Access Compliance Report

Public Rights-of-Way

Intersection ID: 27286	Main Street: ELMSTONE_DR	Cross Street: THORNHILL_CLUB_DR	Location: SW
ADA ID: 22074BC418AC	Ramp Type: PerpDiag	Initial Pass/Fail: Fail	Overall Compliance: No
			Severity Score: 21.25

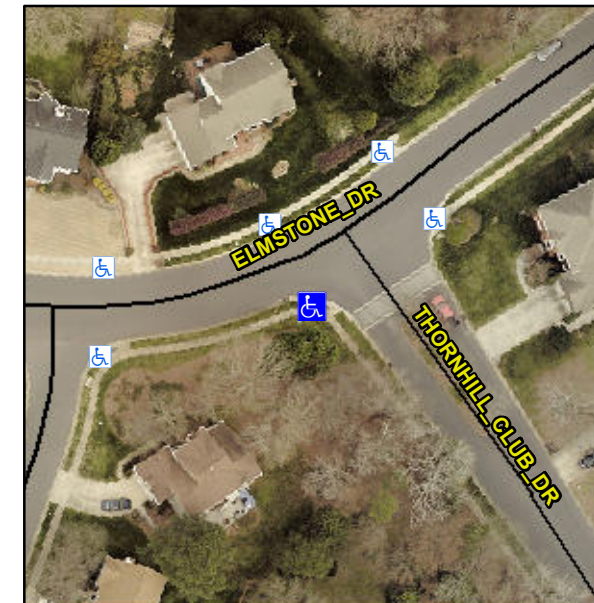
Not Found, R304.5.1, R304.5.3

Compliance	Description	Data	Compliance	Description	Data
N/A	Ramp Length (in)	92.0	Yes	Ramp Slope (%)	6.2
No	Ramp Width (in)	45.5	No	Ramp XSlope (%)	5.2
N/A	Flare Type LT	N/A	N/A	Flare Type RT	N/A
N/A	Flare Slope LT (%)	N/A	N/A	Flare Slope RT (%)	N/A
N/A	Flare Traversable LT?	N/A	N/A	Flare Traversable RT?	N/A
N/A	Landing Length (in)	N/A	N/A	DWS Provided?	N/A
N/A	Landing Width (in)	N/A	N/A	DWS Contrast?	N/A
N/A	Landing Slope (%)	N/A	N/A	DWS Length (in)	N/A
N/A	Landing X Slope (%)	N/A	N/A	DWS Full Width?	N/A
N/A	Landing Curb? (Y/N)	N/A	N/A	DWS Offset (in)	N/A
N/A	Shared Landing?	N/A			
N/A	Gutter Ponding?	N/A	N/A	Gutter Slope (%)	N/A
N/A	Gutter Lip Ht (in)	N/A	N/A	Gutter X Slope (%)	N/A
N/A	Painted X Walk1?	No	N/A	Painted X Walk2?	No
	X Walk 1 Direction	To NE		X Walk 2 Direction	To N
N/A	X Walk 1 Width (in)	N/A	N/A	X Walk 2 Width (in)	N/A
	X Walk 1 Slope (%)	5.5		X Walk 2 Slope (%)	7.6
	X Walk 1 X Slope (%)	8.0		X Walk 2 X Slope (%)	0.7

Remove & Replace Curb Ramp With Two New Directional Ramps or Equivalent.
